January 8, 2020

Re: Comments on the *Revised Data Gaps Work Plan*, dated January 29, 2019, prepared by Dalton Olmsted Fuglevand (DOF).

- **Site Name:** Taylor Way and Alexander Avenue Fill Area (TWAFA)
- **Site Address:** 1500 Block Taylor Way E, Tacoma, Pierce County, Washington
- **Draft Agreed Order:** DE 14260
- **Facility/Site No.** 1403183
- **Cleanup Site ID No.** 4692

Figure 3, Historical Operations Site Plan

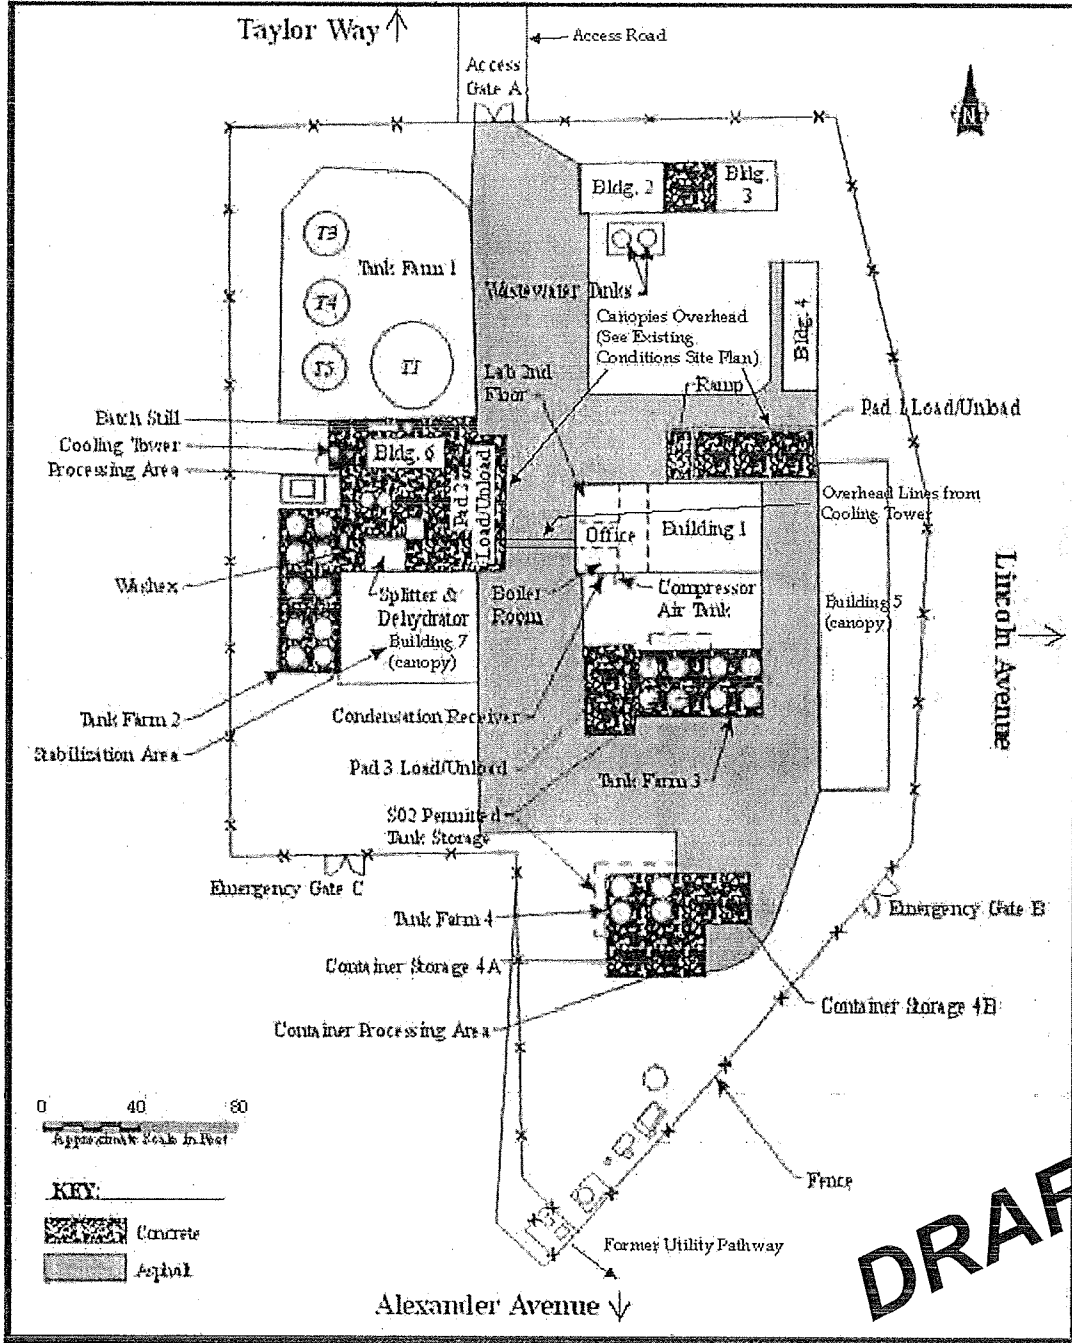
5. Section 5.2, Indoor Air Assessment – Proposed Tasks: Enclosed Figure 3 shows the building designations for the CleanCare facility and enclosed Figure 11 shows the approximate extent of buried lime-solvent sludge.³ Enclosed Figure 15⁴ shows the approximate extent of lime-solvent sludge and lime waste beneath both the CleanCare and Stericycle facilities. As shown in these figures, the approximate extent of lime-solvent sludge includes areas beneath CleanCare Buildings 1, 2, and 3. Therefore, the work plan shall include, as an initial task, a Tier 2 vapor intrusion assessment of these buildings. Of additional concern is the oily water sewer system which has the potential to provide preferential pathways for vapor intrusion (see attached Figure 8).⁵ Please revise the work plan text accordingly.
